Niagara Mohawk

Subject: *Request for Additional Information Regarding Generic Letter 96-06 Dated June 1, 1998 Concerning Nine Mile Point Units 1 and 2 (TAC Nos. M96836 & M96837)*

NMPI RESPONSE TO GL 96-06 RAI

NMP2 RESPONSE TO GL 96-06 RAI

NIAGARA MOHAWK	NINE MILE POINT NUCLEAR STATION - UNIT 2 SCRBA, N.Y.
	SIMPLIFIED FLOW DIAGRAM REACTOR BUILDING CLOSED LOOP COOLING WATER SYSTEM
SCALE	DRAWING NO 96-06 RAI SKETCH, SHEET 2

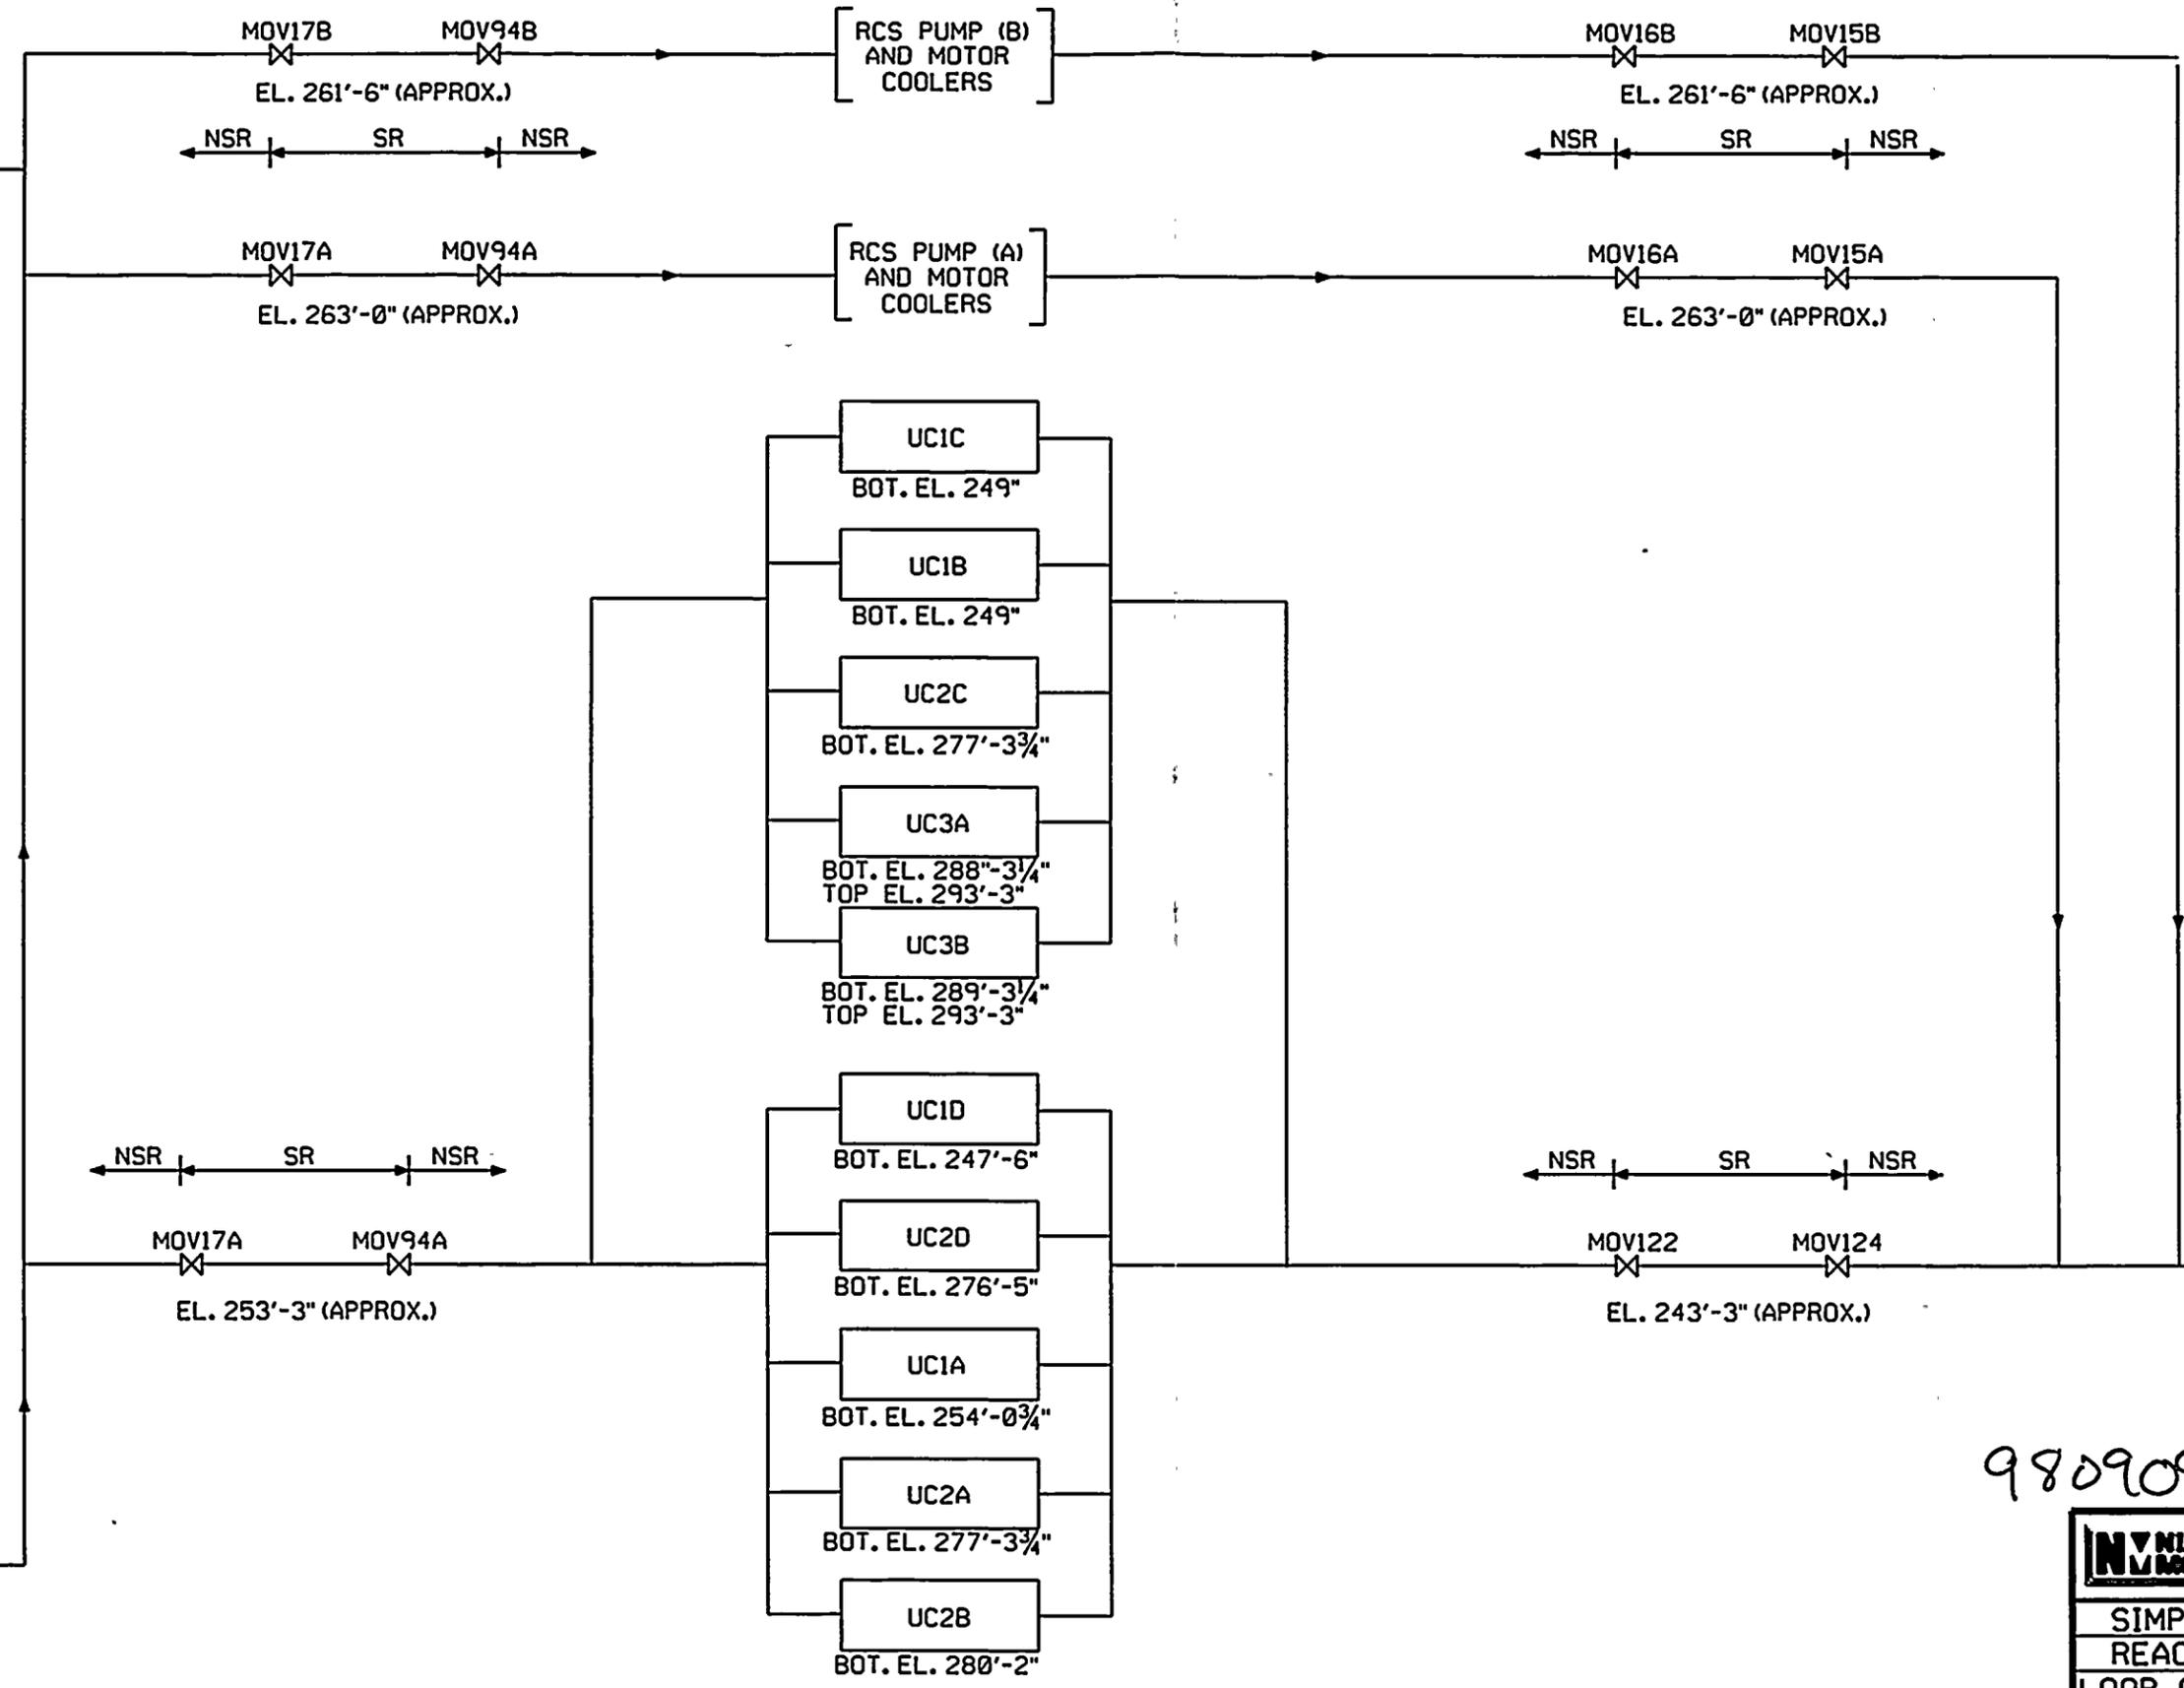
Provide a simplified diagram of the affected cooling water systems showing major components, active components, relative elevations, lengths of piping runs, and the location of any orifices and flow restrictions.

The attached sketch provides all the requested information except lengths of piping runs. Complexity of RBCLC piping inside the drywell does not allow inclusion of piping lengths in the simplified sketch. Piping isometrics can be provided if more detail than shown on the simplified sketch is desired.
